**Assessment of Specialist Studies for draft Oran Park Development Control Plan
Amendment – 531 Cobbitty Road, Cobbitty**

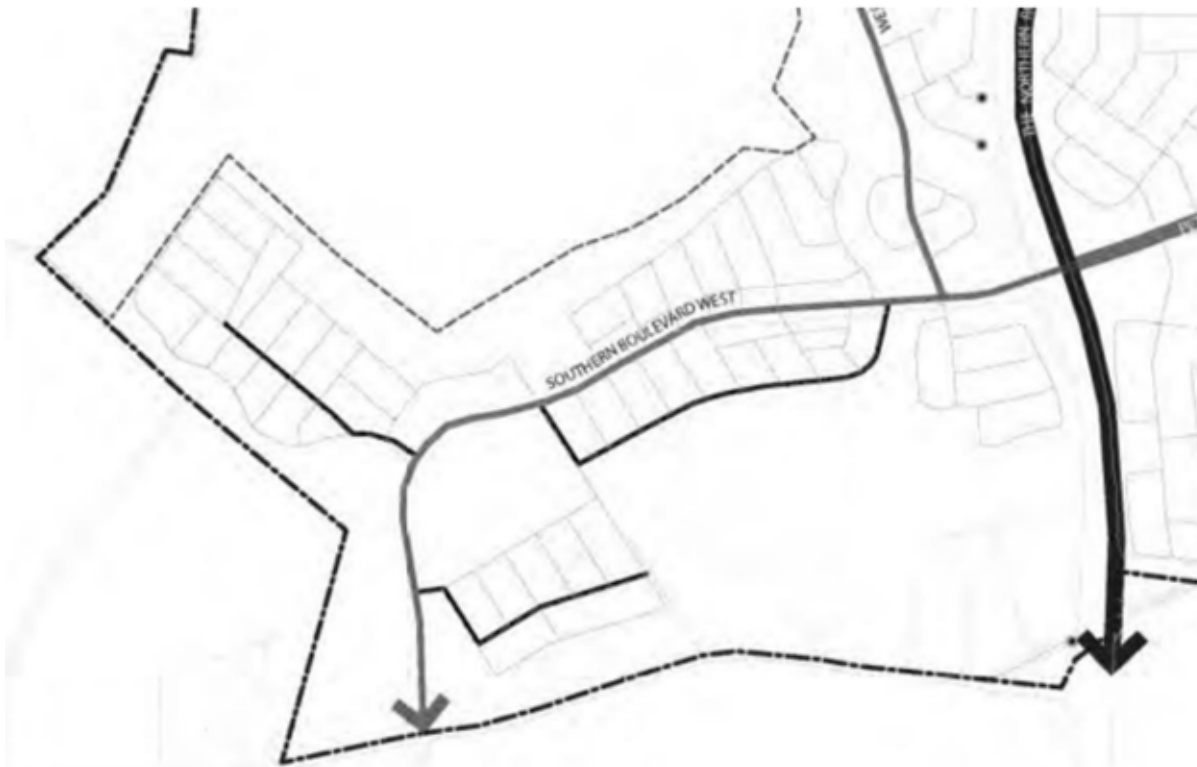
The current DCP identifies a landscaped earth mound to avoid adverse visual impacts of future developments on the rural setting of the Denbigh Estate and on the views from the Denbigh Homestead and outbuildings group (core curtilage). The revised proposal maintains the integrity of Denbigh's heritage curtilage as it results in improvements to the heritage curtilage by providing a more responsive earth mound to reflect the topography of the site. The proposed design also reduces the amount of land required on the adjacent Denbigh Estate.

The proposed amendments remain consistent with the vision of the Oran Park DCP, in particular the specific controls set out in Part B of the DCP relating to the Denbigh Southern Viewscape Precinct. The proposed amendments will facilitate the future development of the earth mound which aims to balance the objectives of the DCP, Conservation Management Plan and the Curtilage Study for the 'Denbigh Transition Area' in anticipation of future development of the subject site. To ensure the future development of the earth mound meets the objectives of the DCP, deviations from the maximum height limit of 4.5m have been proposed. This also include updates to the extent of cut and fill within the ridgeline to reduce the extent of the earth mound required to be burdened on the adjoining landowner.

Despite the proposed modifications, the earth mound design remains consistent with the design features as required in the DCP (Figures 4a, b, c, and d). These include:

- A gradual integration of the batter with the adjoining rural pastures at the foot of the earth mound. A gradual slope of 1:6 to 1:5 is proposed for the ridgeline, and the slope at the foot of the batter ranges from 1:5 to 1:8.
- A landscaped mound with a combination of scale and type of native species planted to ameliorate potentially negative visual impacts of the height of the earth mound.

The extent of cut and fill proposed achieves a minimum screening height of 6 metres for the future development. The proposed design eliminates future possibility of roof lines, streetlights or car headlights being visible from the Denbigh core curtilage and reflects the broad aims and objectives of the DCP by providing visual screening and protecting Denbigh's rural heritage. The proposed DCP amendments also maintain the current controls for residential development within the Transition Area, to ensure that dwellings do not protrude above the ridgeline and are constructed to maintain the appearance of a single-storey dwelling when viewed from the rear.

Although the proposed mound significantly alters Cluny Hill's function as a gatehouse to the Denbigh Estate, the HIS concludes that the future landscaped mound will visually screen future development from the Cluny Hill collection of buildings.

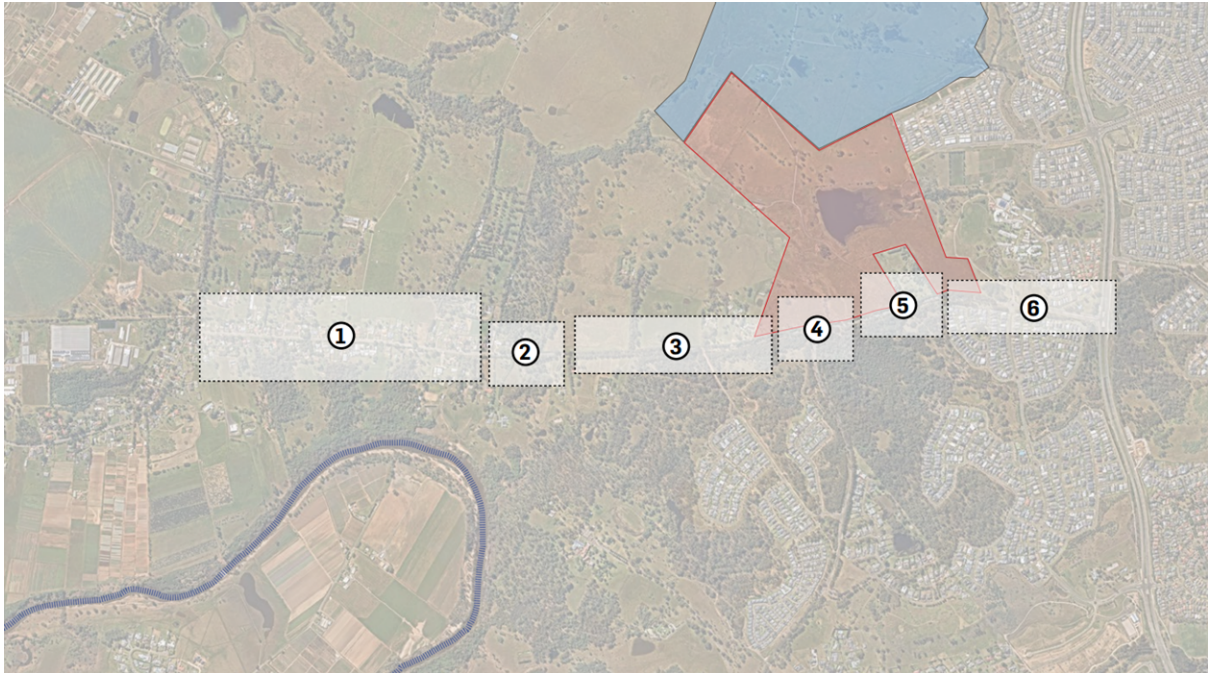
The potential traffic impacts associated with the proposed DCP amendments, on the surrounding critical road network, have been considered as a result of the proposed Masterplan update. It is noted that the proposed residential dwellings satisfy the minimum yield dwelling target of 414 as suggested in the ILP.

The proposed trip generation associated with the updated Masterplan is distributed to the surrounding road network.

Overall, the proposed updates to the road network aim to improve the overall traffic network for the Oran Park Precinct and result in positive benefits in relation to site accessibility and road network permeability. The proposed updates also aim to improve pedestrian and active transport connections by moving connector roads to the periphery of the site and creating improve connections to public facilities and riparian corridors.
